# Bulletin

SRN - 1347  
 APC - 432,466  
 Sept 2001

From: MTS2000 Subscriber Product Group  
 Subject: **In-Band High Level Intermodulation Enhancement for MTS2000 800MHz Radios**

**Figure 2 – Orientation of Capacitor part number 2113740A06**

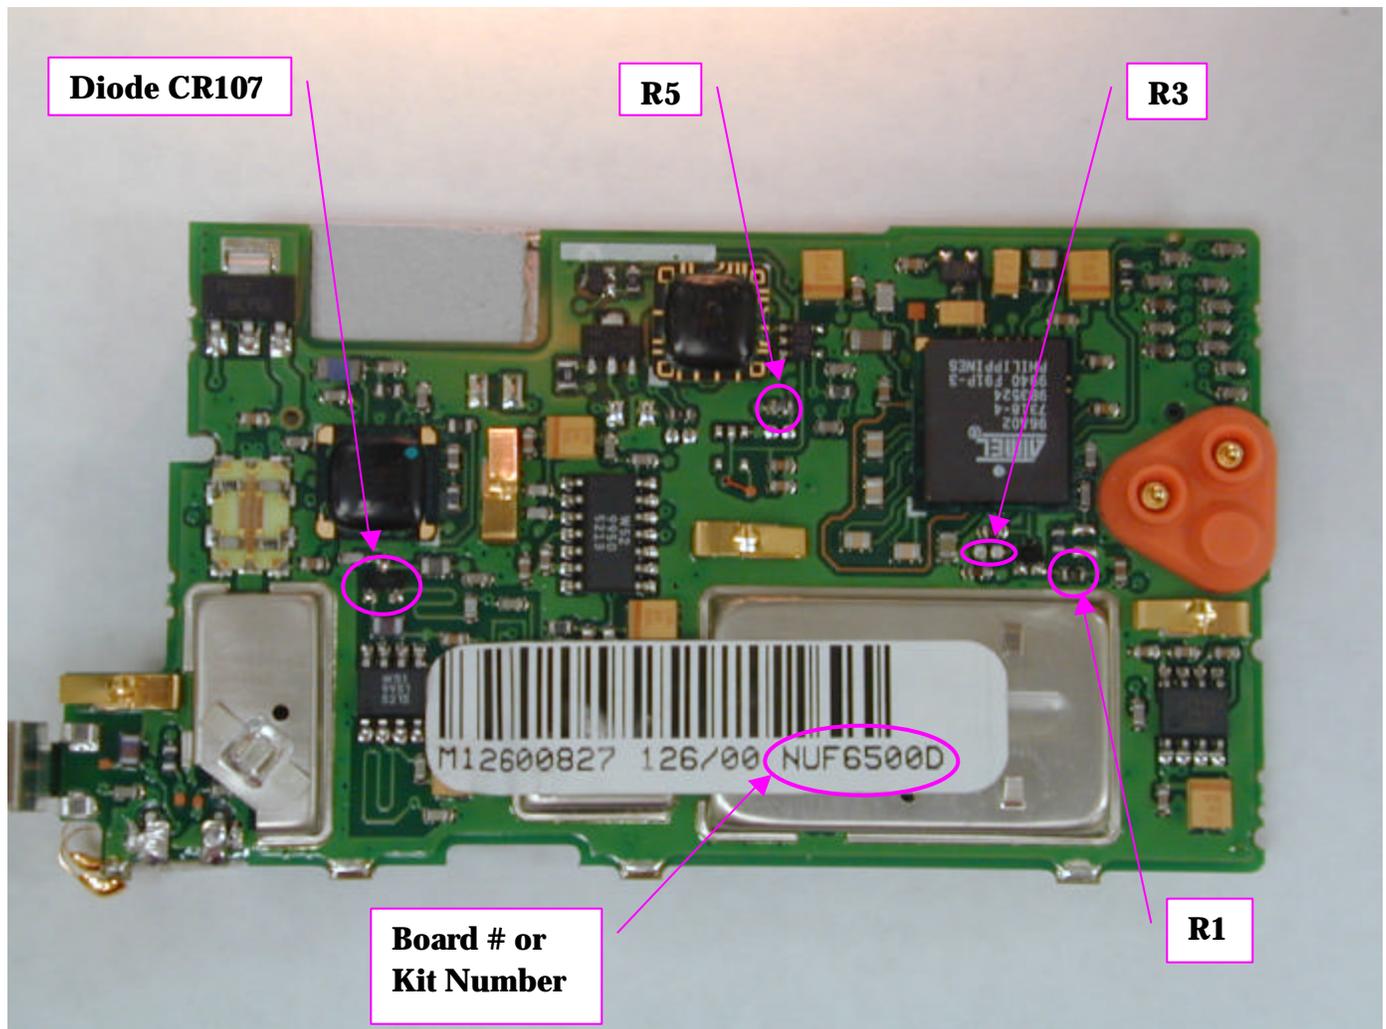
1. Disassemble the radio in accordance with section 6 of the manual (pg. 29 – 33); kit number is located on the bar code label on the PCB as shown in Figure 1.
2. Remove Diode CR107 shown in Figure 1.
3. Place Capacitor part number 2113740A06 in place of the diode as shown in Figure 2. One end of the capacitor should bridge two of the diode pads.
4. Re-assemble the radio in accordance with section 6 of the manual (pg. 36 - 38).

## Figure 1 - Location of Components

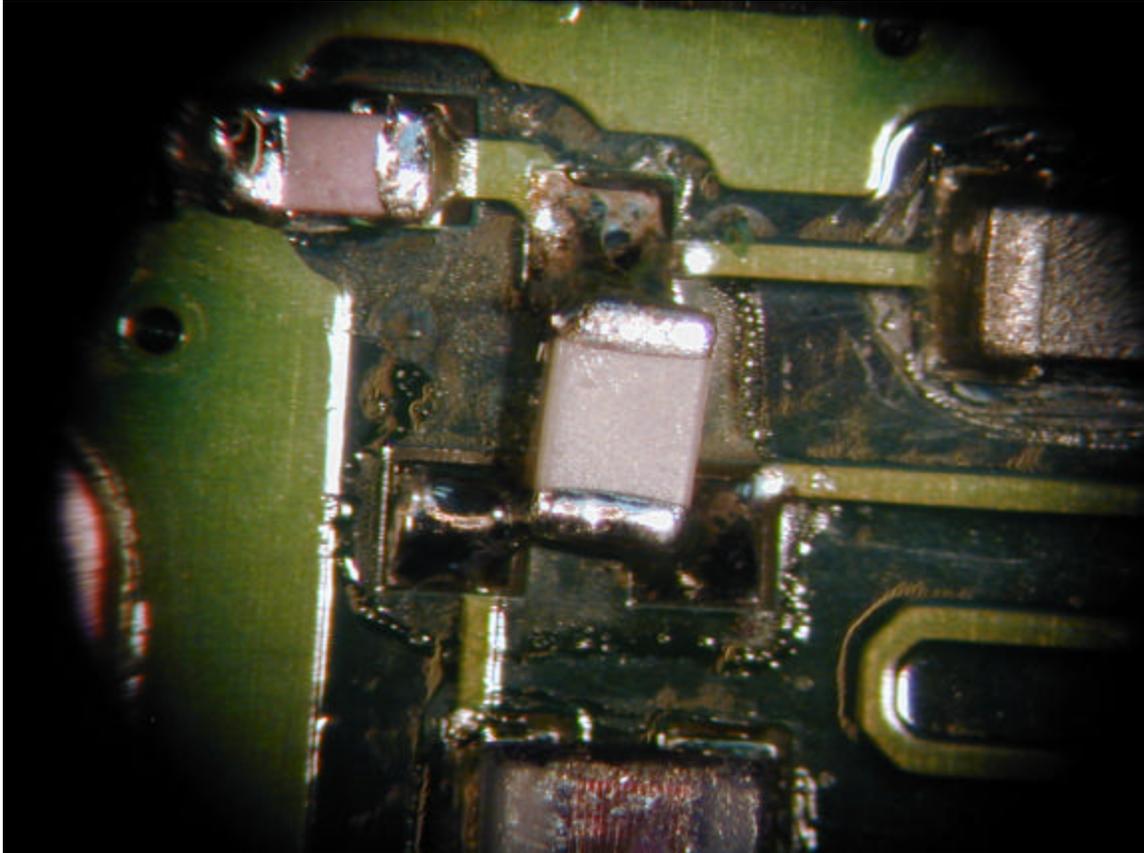
1. Disassemble the radio in accordance with section 6 of the manual (pg. 29 – 33).
2. Replace resistor R1 with part number 0662057A42
3. Remove resistor R3.
4. Place resistor R5, part number 0662057A73, in location shown in Figure 1.
5. Re-assemble the radio in accordance with section 6 of the manual (pg. 36 – 38).
6. If the **radio** contains **firmware older than R06.50**, upgrade the radio firmware to the latest release.
7. Perform basic Sensitivity and power test to verify radio's basic functionality
